A12 32 + Drawings  
E. R. Squibb & Sons, Inc.

This is in response to your letter of February 18, 1982 in which you requested additional information with respect to Squibb's Radiological Contingency Plan. Each of your comments have been addressed in the enclosure. Also included are additional or replacement pages for the required information.

### Response to Comments on Squibb's Radiological Contingency Plan

FIGURE 1. Portion of Middlesex County, New Jersey, showing location of the E. R. Squibb and Sons facility.

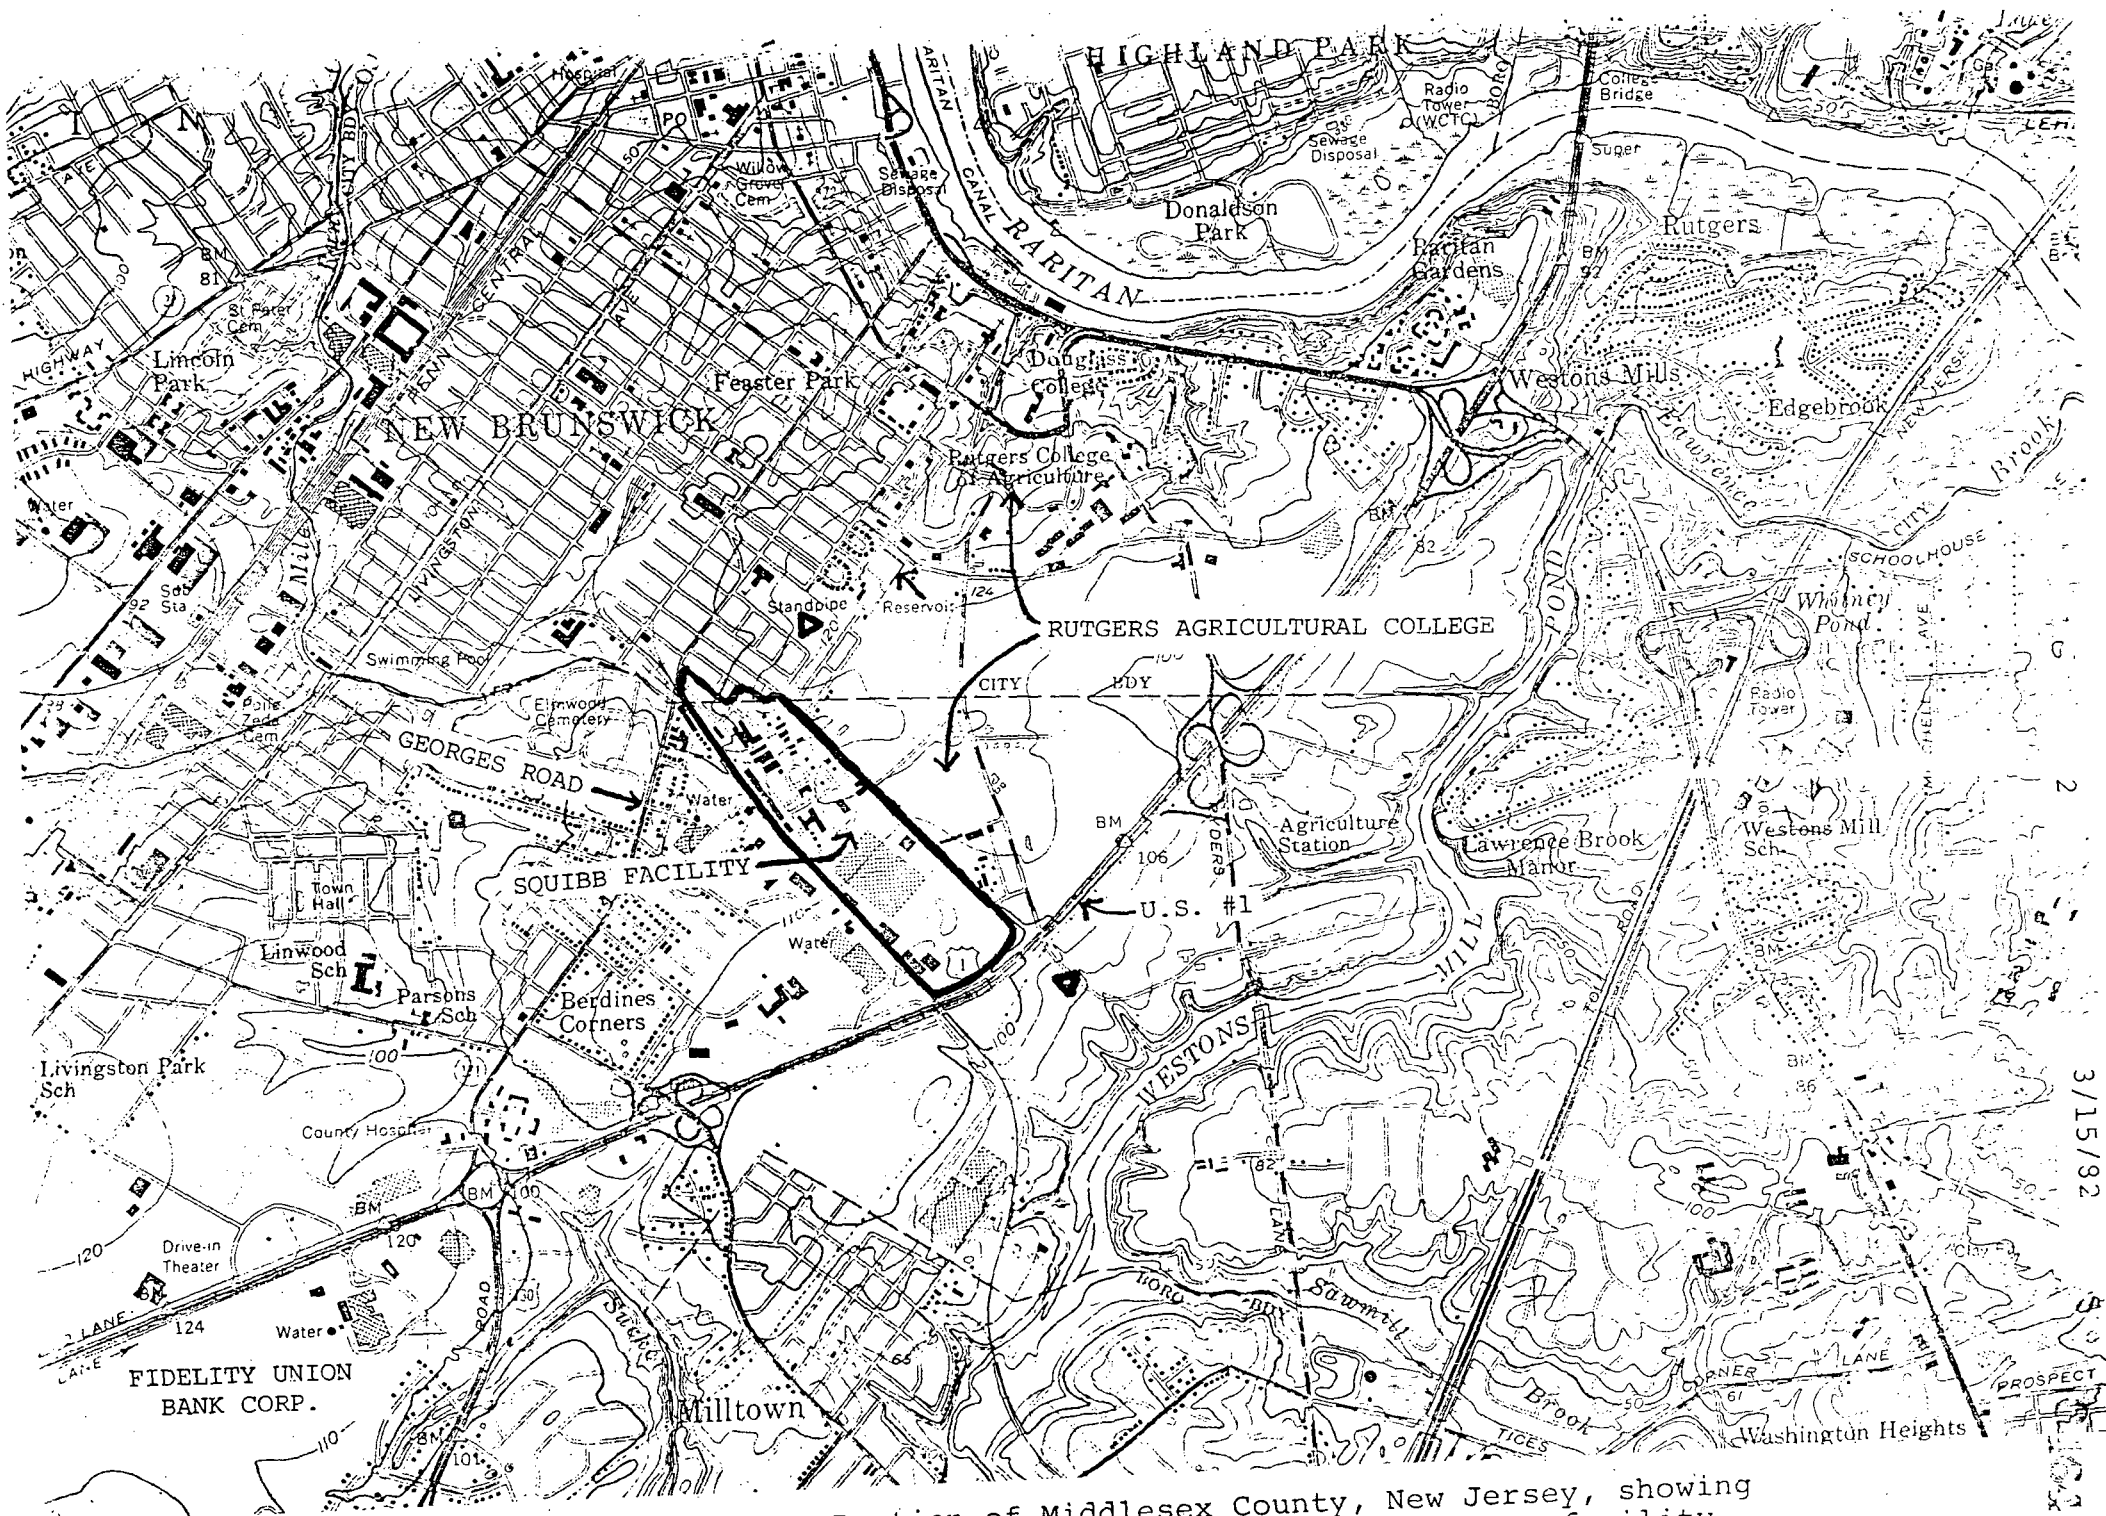
Figure 1., the topographical map which is considered of poor quality has been replaced with one more readable. Also included as part of the site plan is an additional map (Fig. 3a) which depicts the locations of population centers near the site, such as university dormitories or classrooms on the agriculture college.

The Figure 1 replacement and the Figure 3A addition are enclosed.

## EXISTING CAVES VENTILATION SYSTEM

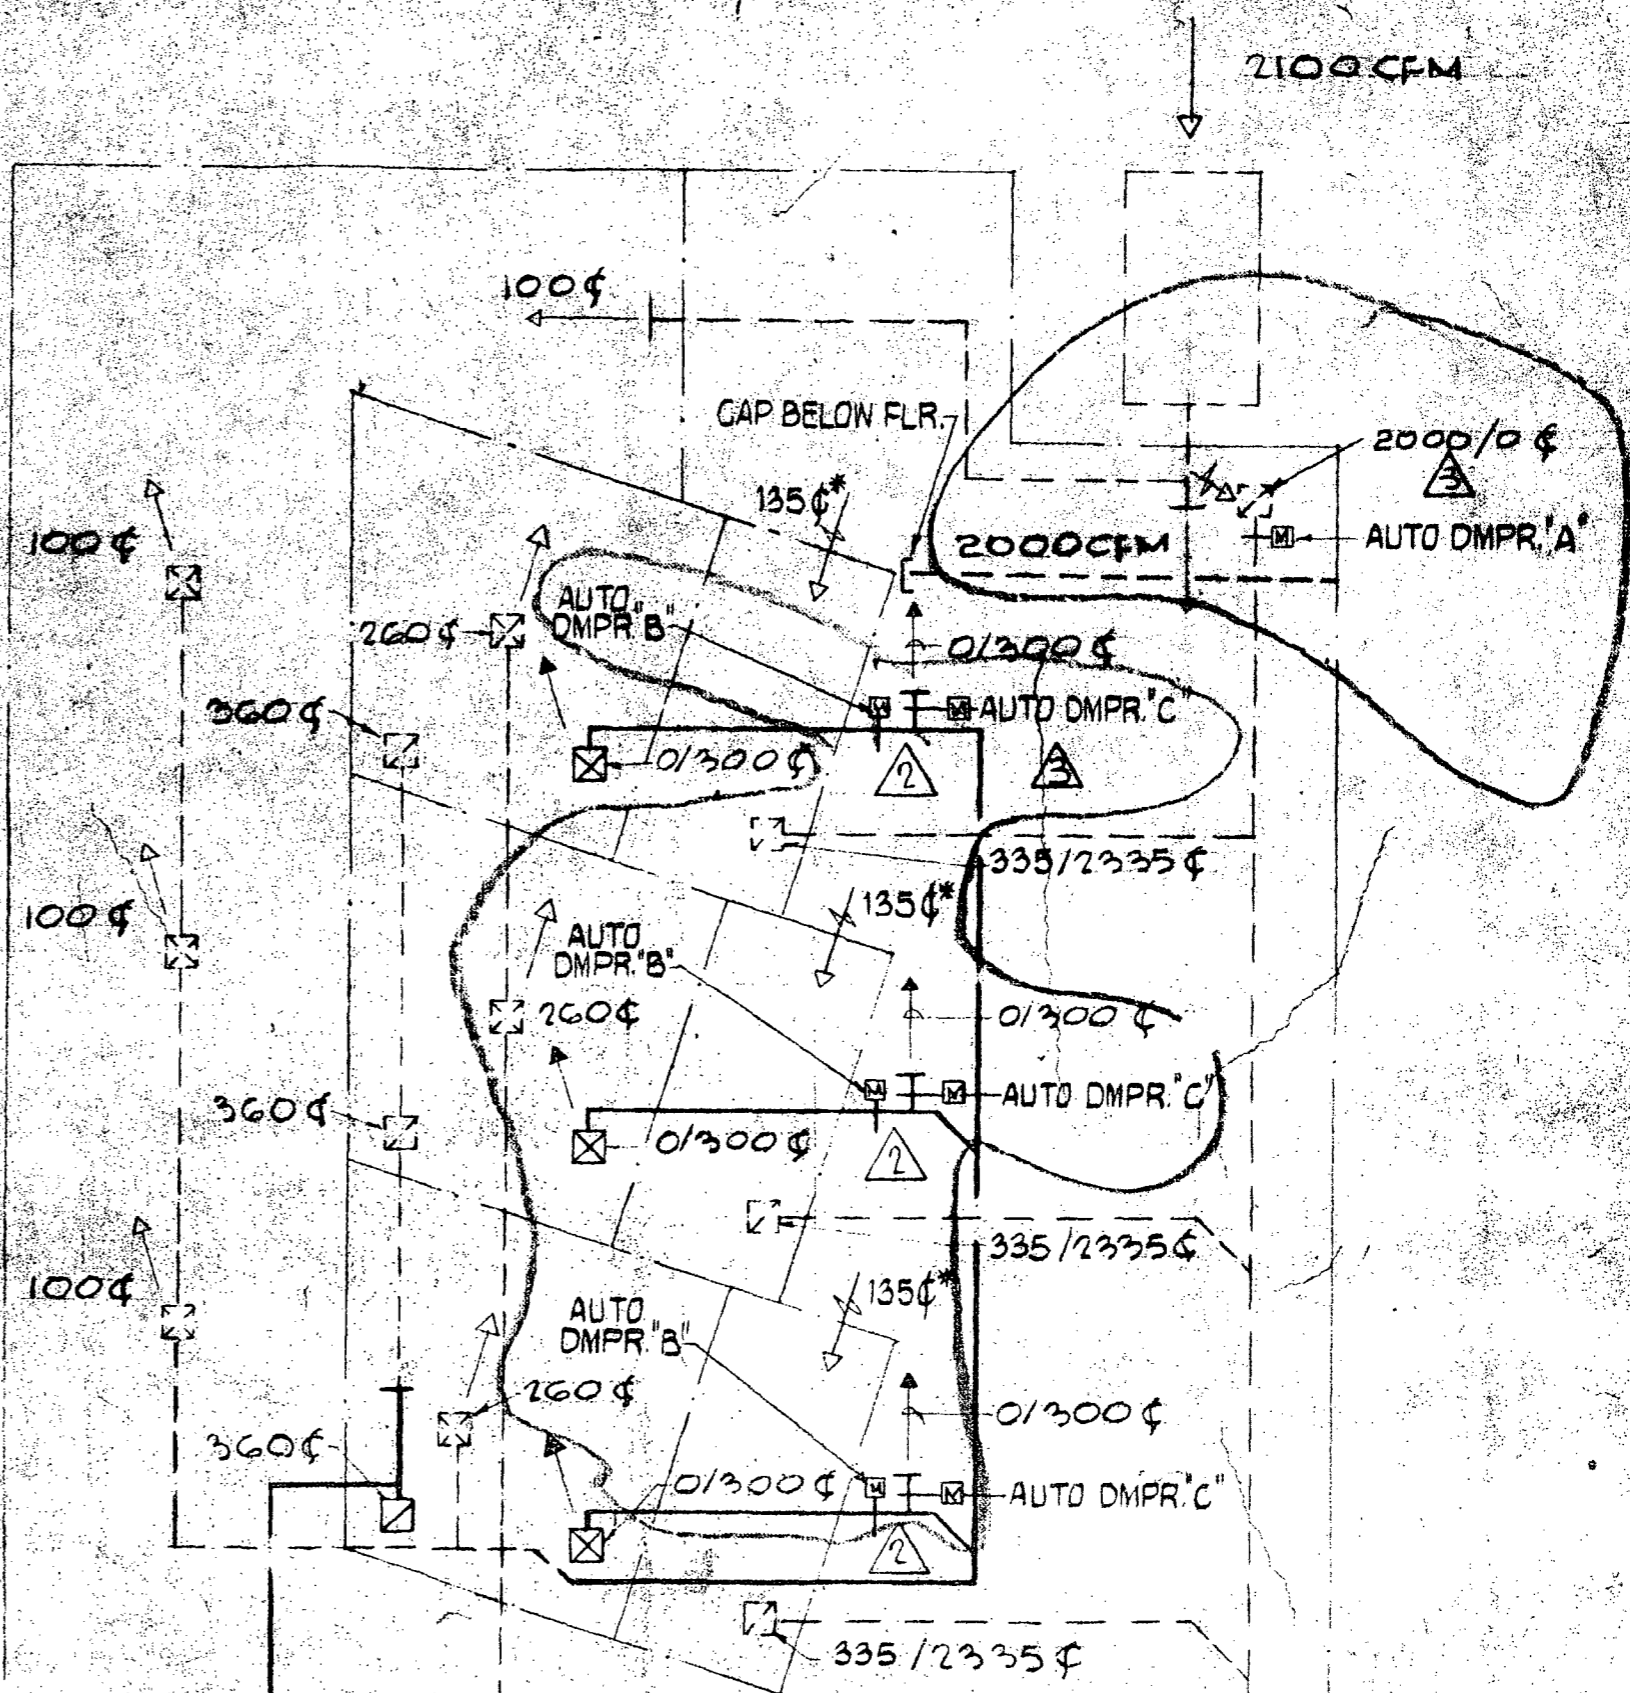
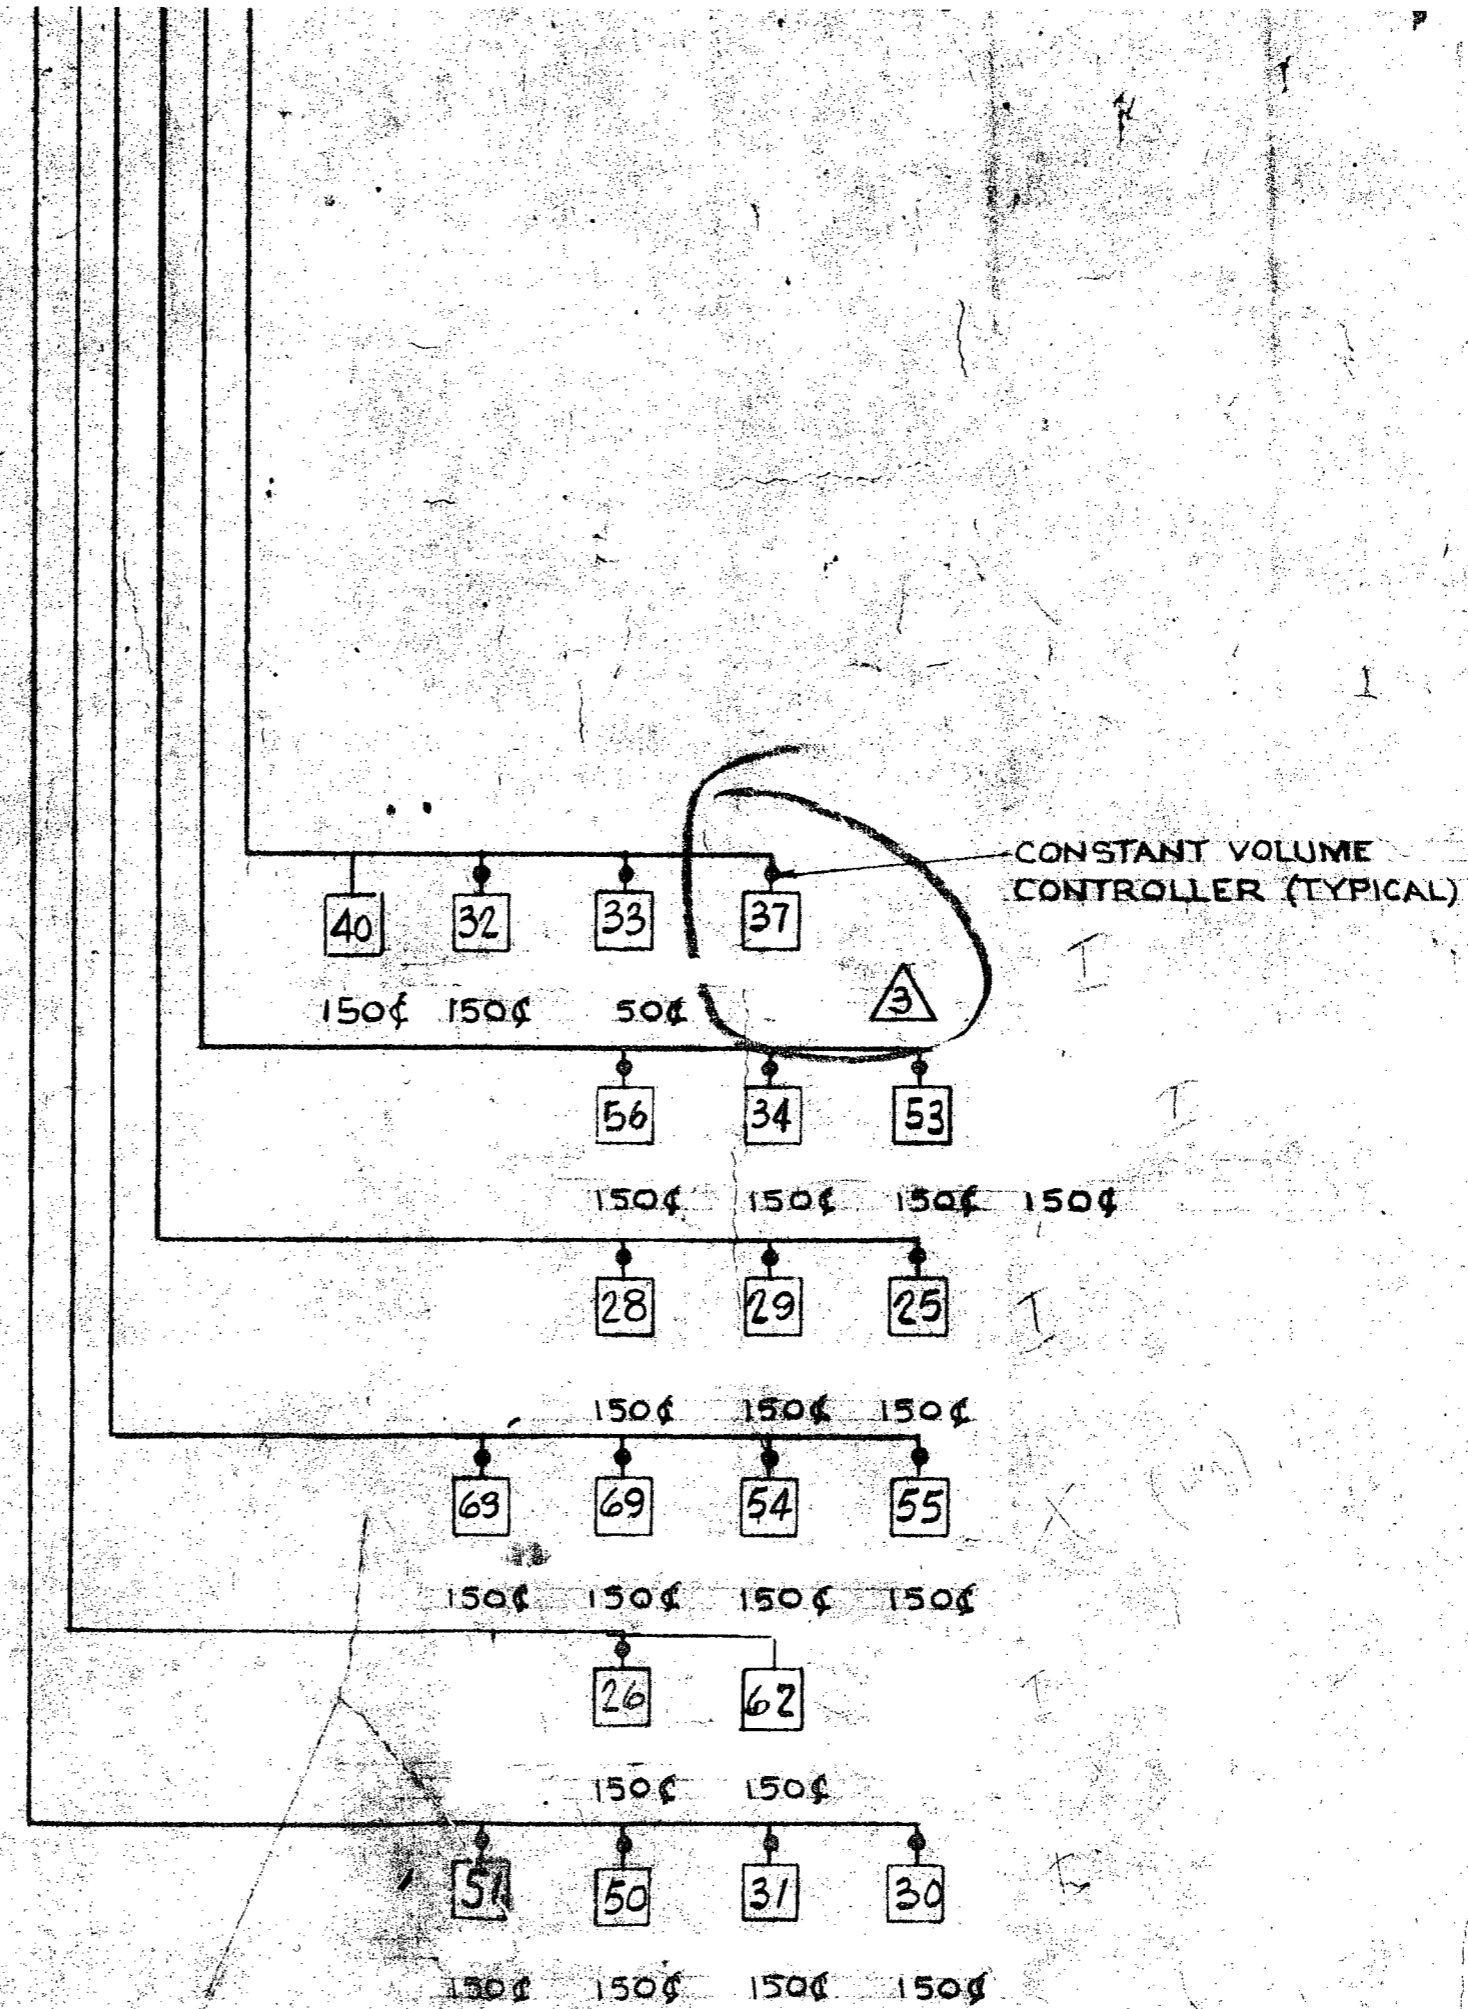
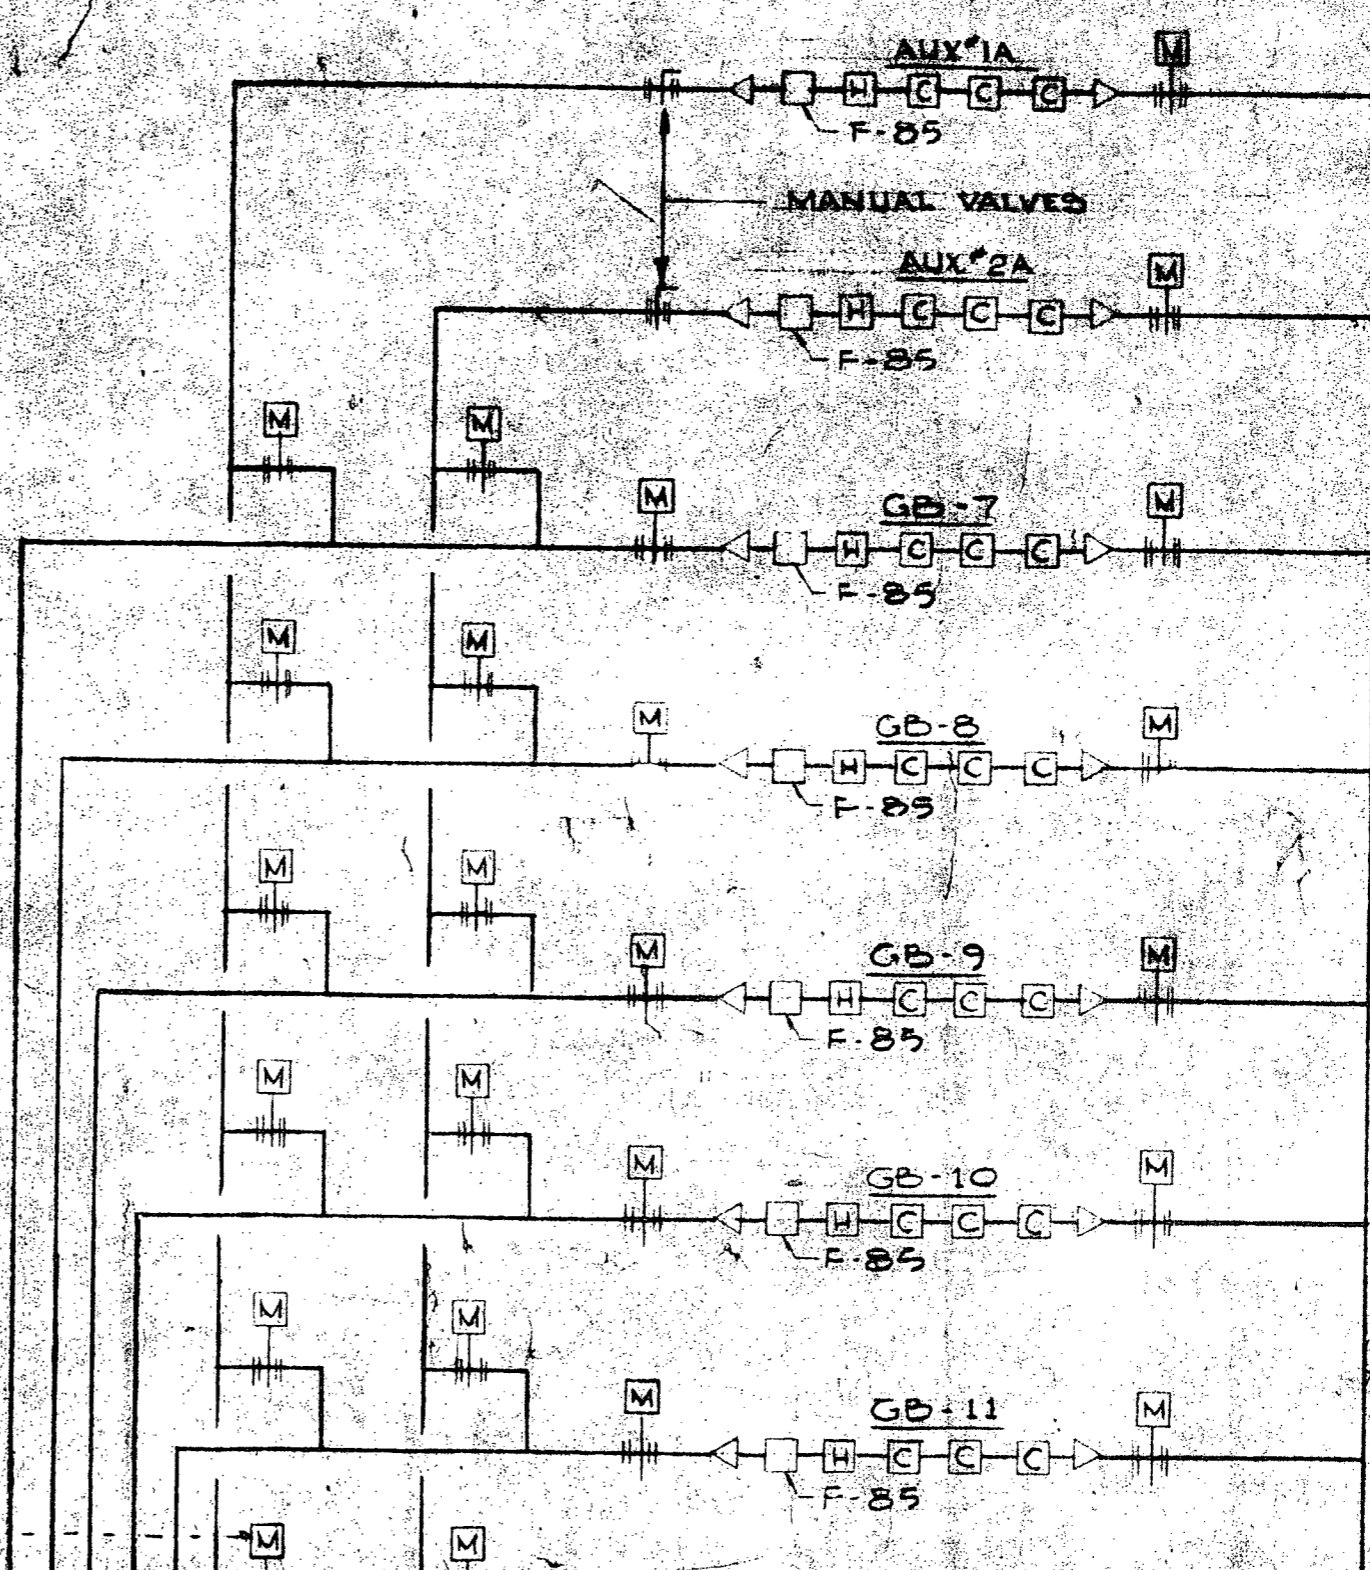
Schematic drawings showing the relationships among the glove boxes, fume hoods, hot cells and filter banks with associated ducting have been referenced in this section.

These drawings have been added as an addendum to the plan.
